Commissioner Anthony Eggert, Presiding Member
Vice Chair James D. Boyd, Associate Member
Mr. Craig Hoffman, Project Manager
Abengoa Mojave Solar Project (09-AFC-5)
California Energy Commission
1516 Ninth Street
Sacramento, CA 95814

Re: Abengoa Mojave Solar Project (09-AFC-5): Revised Second Supplemental Written Response to Data Request Set 1A (nos. 1-93) for Air Quality and Public Health

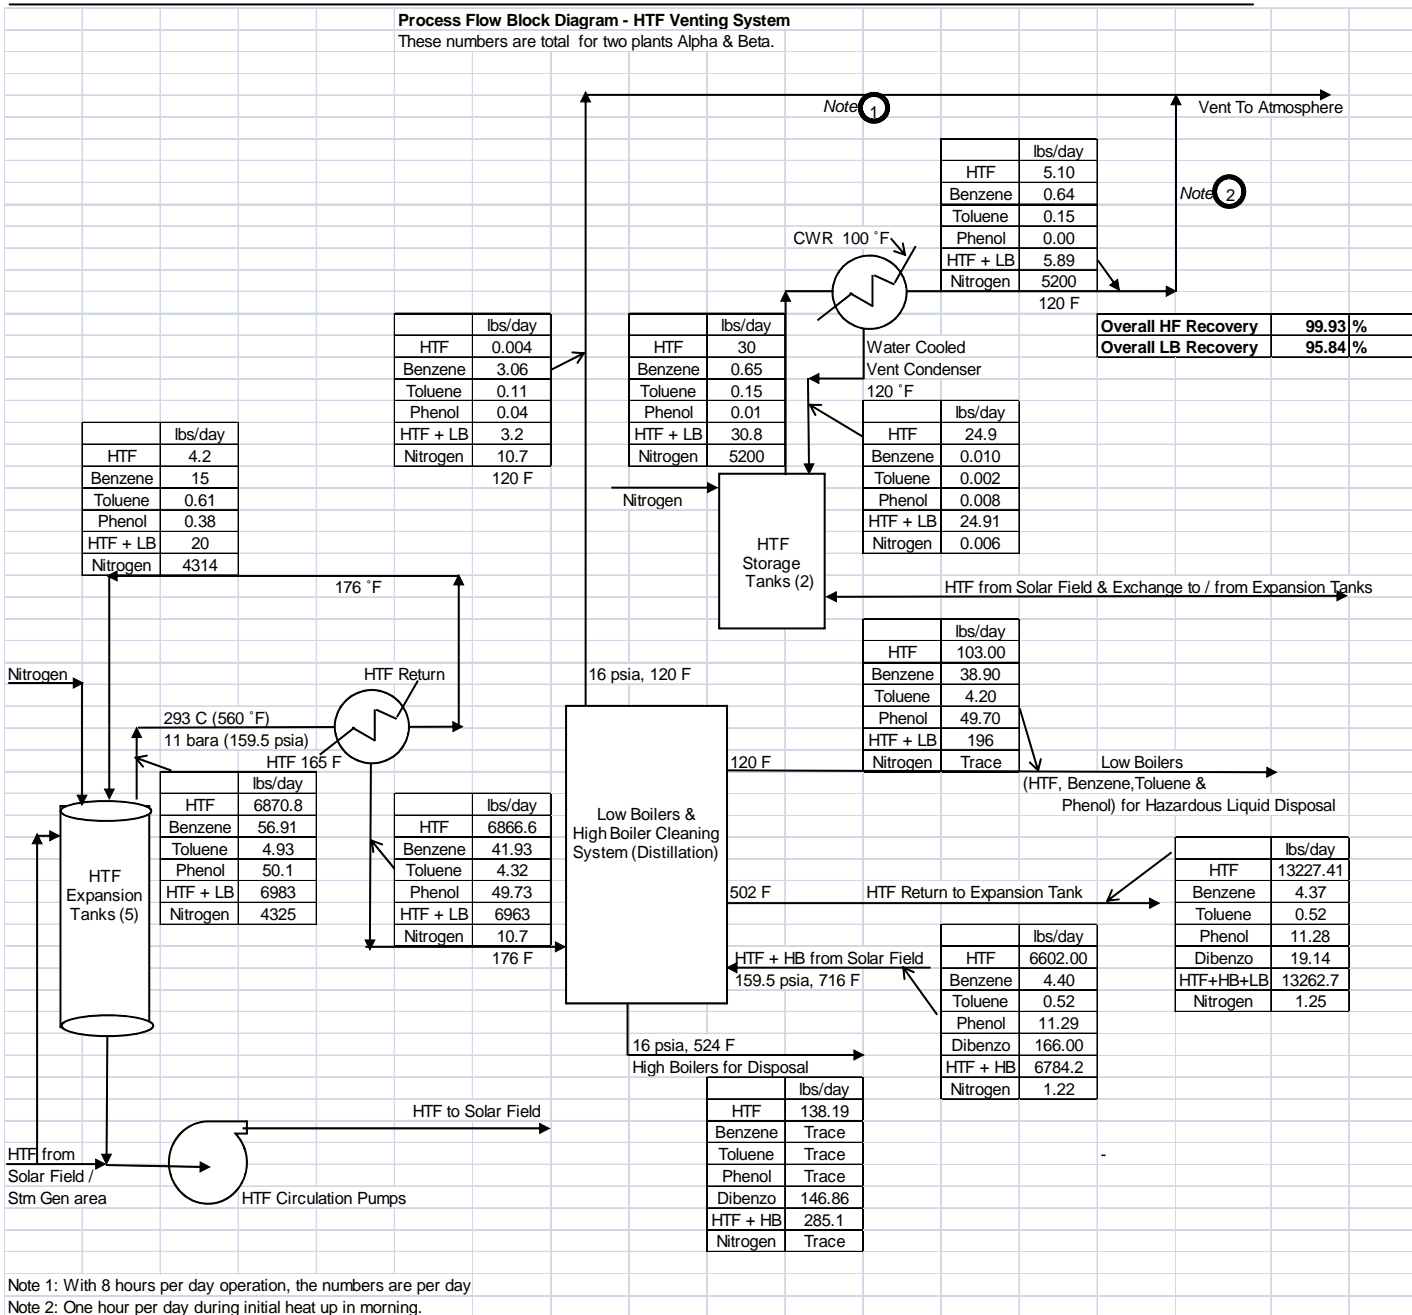
Please identify whether the applicant is willing to stipulate to the incorporation of a carbon adsorption, or other VOC control system, to control VOC emissions from the HTF expansion system venting by at least 98 percent. If unwilling to stipulate to this condition, please identify the basis for this position.

The Applicant proposes the following system for VOC control from the HTF expansion system, which will achieve a minimum overall VOC emissions control efficiency of 98%.

The Mojave project has two identical Alpha and Beta plants. The numbers on the following flow diagram are totals for both plants together. The HTF system of each plant will consist of 5 vertical ASME-rated expansion tanks, one nitrogen-condensing ASME-rated tank (same size as expansion tank) and two vertical HTF storage tanks.

These expansion tanks and the nitrogen condensing tanks will be sized such that during normal operation the expansion/contraction of the HTF will be kept within these tanks and an initial fill of nitrogen will also be kept within tanks by allowing the nitrogen/vapor space pressure to vary from 3 bara to 11 bara nominally. However, after filling all pipes initially at ambient temperature (with high density – lower specific volume), the expansion of the HTF from the ambient temperature to the daily operating temperatures will push the HTF that is not needed in the system during daily operation from the expansion tanks into two storage tanks that will be kept cooler (at about 165 °F) and blanketed with 2-15 inches Water Column (in. WC) nitrogen pressure.

During daytime operation, when the HTF is heated and expands, the expanded volume will move into the expansion tanks and the nitrogen will be compressed and pushed into the nitrogen condensing tank. At night when the HTF cools and contracts, the HTF will move back into the piping and the nitrogen in the vapor space will expand into the expansion tanks.
